AKHL1050E

BULLETIN NO. AKHL1050E – 01
DATE OF CHANGE March 2008 Production
DATE April 18, 2008

Subject : Improvement of Fan Pulley

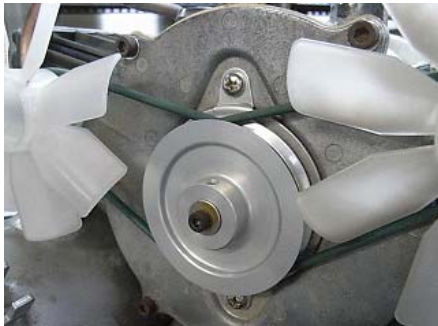
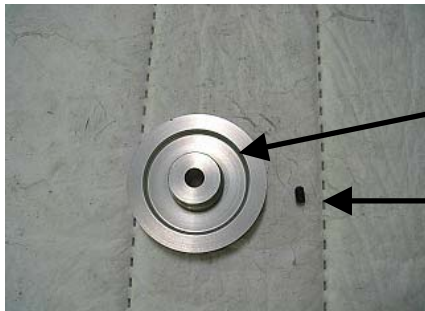
AK13705 **FAN PULLEY** has been improved durability by changing to new aluminum material instead of plastic material. Make sure to fix it by a new **HEX. SCREW 5 X 8** with **Three Bond 1344** or **Loctite 242** after removing oil.

If AA75415 would be too tight to be removed, it is suggested for you that the screw area should be warmed up by dryer to soften loctite.
